ALERT SERVICE BULLETIN

SUBJECT: RUDDER - INSPECTION AND MODIFICATION OF INTERCOSTALS AND TRIM
TAB CONTROL ROD. (MODIFICATION N437)

FIG 1

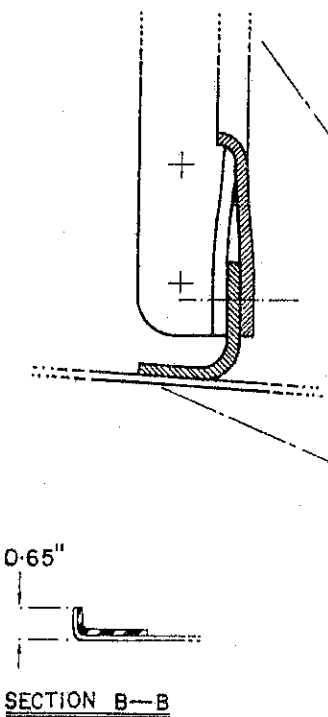
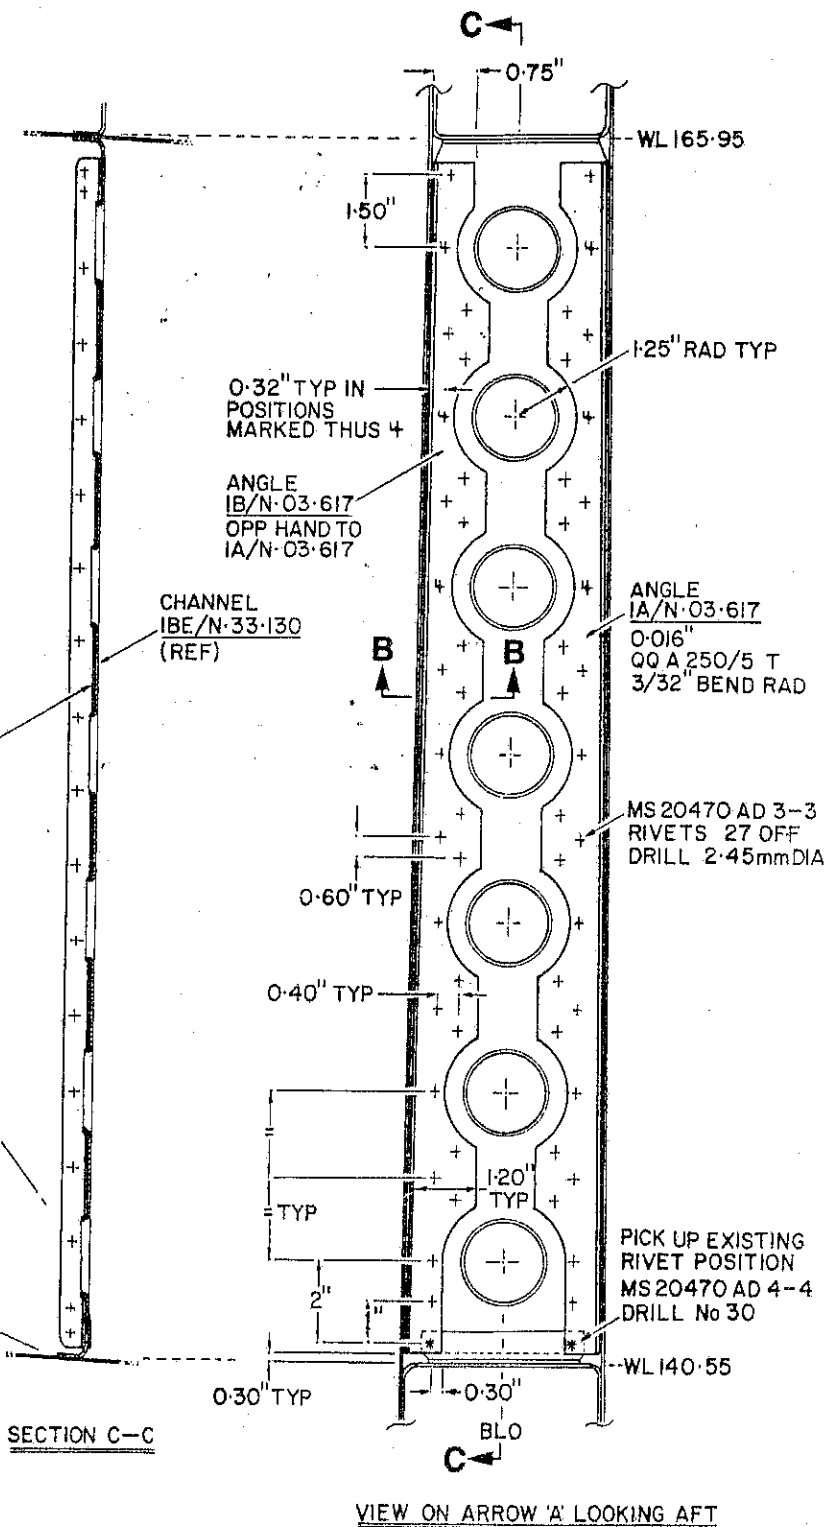
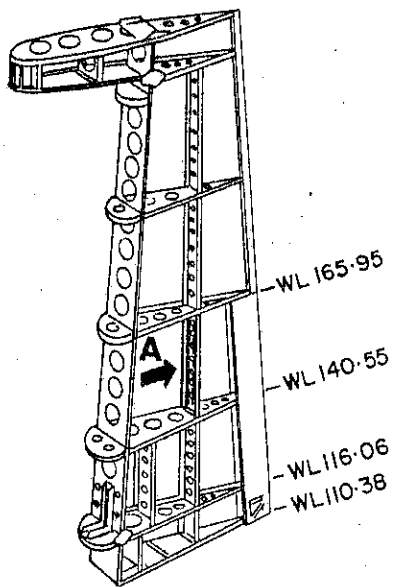
- A. Inspect intercostal between WL 140.55 and WL 165.95 (Ref detail A fig 1 for intercostal location) for working/loose rivets. If more than 3 consecutive rivets are found working/loose they are to be replaced before further flight with AGS 2050 () pop rivets.
- B. Place a straight edge (12 inch steel rule) across flutes along the intercostal rivet line.

- A. Remove rudder from aircraft (Ref M.M. 55-40-00).
- B. Suitably trestle rudder to obviate distortion. De-rivet and remove right-hand side skin between WL 110.38 and 165.95.
- C. Remove intercostal P/N IBE/N-33-130 (ref detail A fig 1 for location).
- D. Inspect intercostal for signs of cracks. No cracks are permissible.
- E. If no cracks are evident, reinforce both flanges of intercostal in accordance with fig 1; or replace with intercostal locally manufactured (heavier gauge without lightening holes) in accordance with figure 2.

Locally manufactured intercostals from heavier gauge do not require the additional flange reinforcing detailed in figure 1.

FIGURE 3

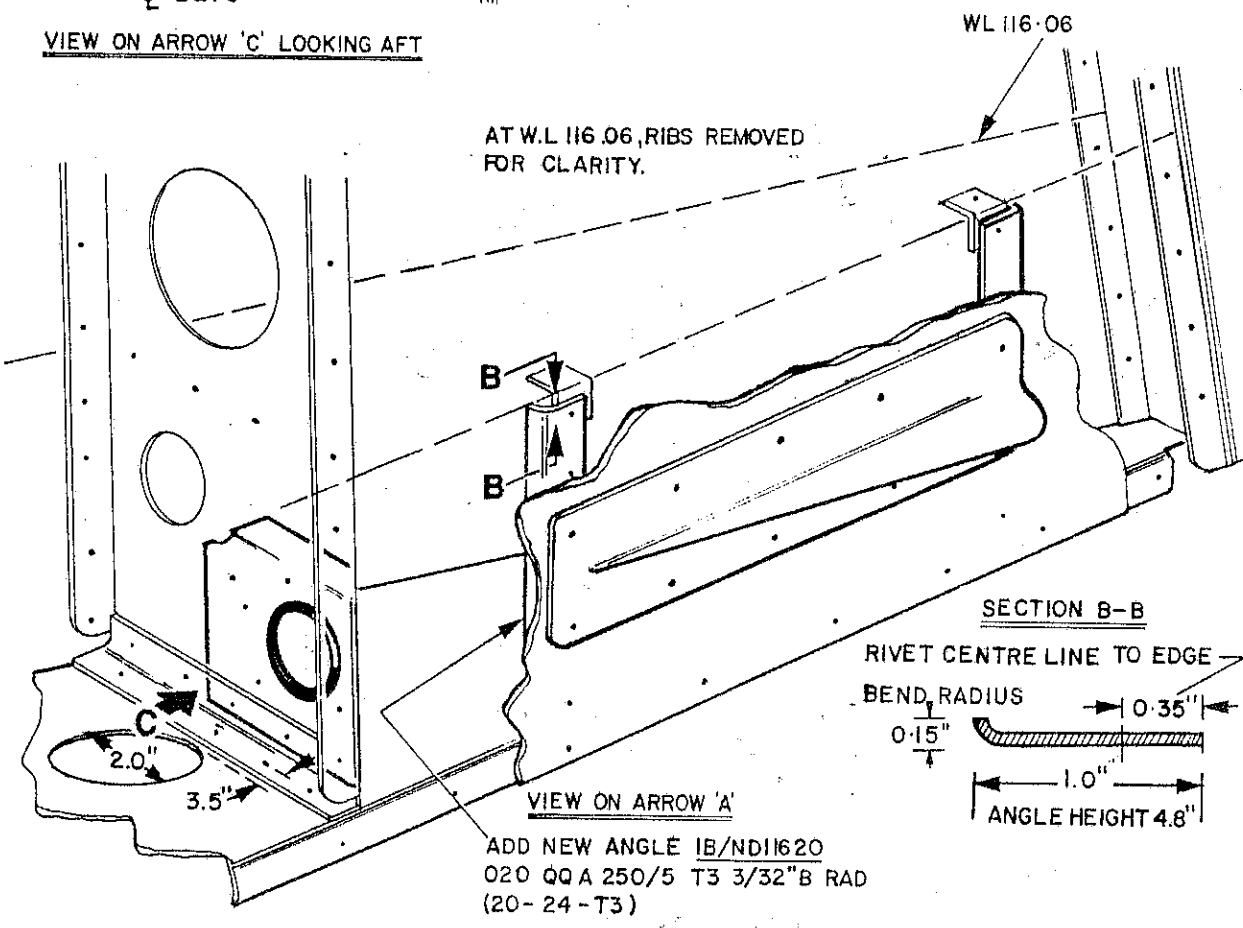
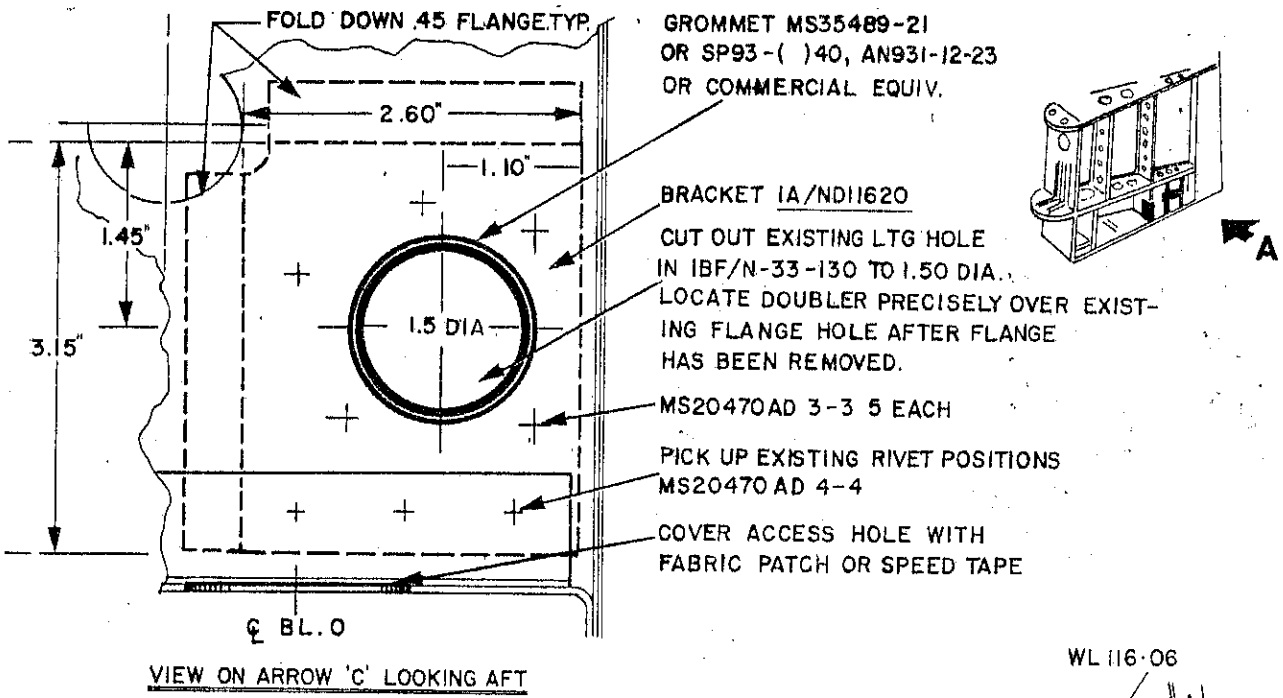
- F. Refit intercostal picking up existing rivet holes.
- G. Remove rudder trim tab control rod. Rework lower intercostal hole and fit reinforcing bracket and grommet in accordance with figure 3.
- H. Cut access hole in lower rib as shown in figure 3. Cover access hole with doped fabric or speed tape or commercial equivalent.
- I. Remove angle and install locally manufactured angle in accordance with figure 3.
- J. Refit rudder trim tab control rod.
